MEMORANDUM

Subject: Official Plan and Zoning By-law Amendment Applications (3rd Submission) – 437202 4th Line

**Re: Duivenvoorden Pit Expansion, Review of Combined Level 1 and Level 2
Hydrogeological Assessment Report (Updated), September 29, 2023, Melancthon
Township, ON.**

**Re: DHL Melancthon Pit
Project No.: 300055091.0000**

Figure 19: Proposed Pit Floor Elevations

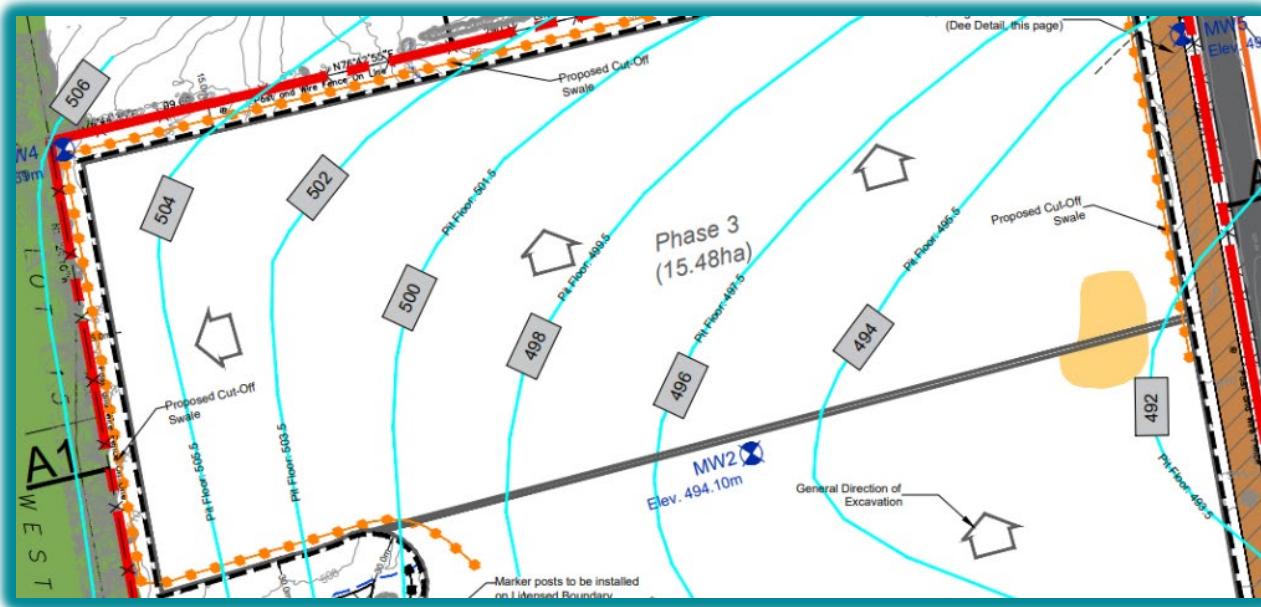
proposed operations are unlikely to significantly affect groundwater or surface water quality or quantity or cause interference to existing private or municipal wells in the area. The shallow groundwater level has been determined adequately enough to establish proposed pit floor elevations being at least 1.5 m above the seasonal high water table level. The data relied upon for this determination was based on the highest determined groundwater levels which were from 2018. The determined proposed pit floor elevations are provided on Figure 19 of the 2023 report. The proposed pit floor elevations provided in the submitted OP should be revised to reflect those shown on Figure 19.

Azimuth completed its hydrogeological review, determined high groundwater levels, and recommended a pit floor to ensure that the required 1.5 m clearance would be achieved. This is all shown in Figure 19 of their report, which is labelled “*Proposed Pit Floor Elevations*” and whose legend shows that the Pit Floor contours are shown in black lines:

The proposed pit floor contours on Figure 19 are as high as 507 m in the northwest corner and as low as 497 m adjacent to 4th Line:

The numbers on the contours should be the same and they are not. The Azimuth contour of 507 m along the west boundary is proposed to be 504 m on the IPS drawing. The Azimuth contour of 497 m adjacent to 4th Line is labelled at an elevation of 492 m on the IPS plan.

The potential implication of an Operational Plan showing lower pit floor elevations than the Hydrogeological plan would be that extraction would not only breach the required 1.5 m separation to the high water table, but with such extreme differences the extraction would actually be within the water table.
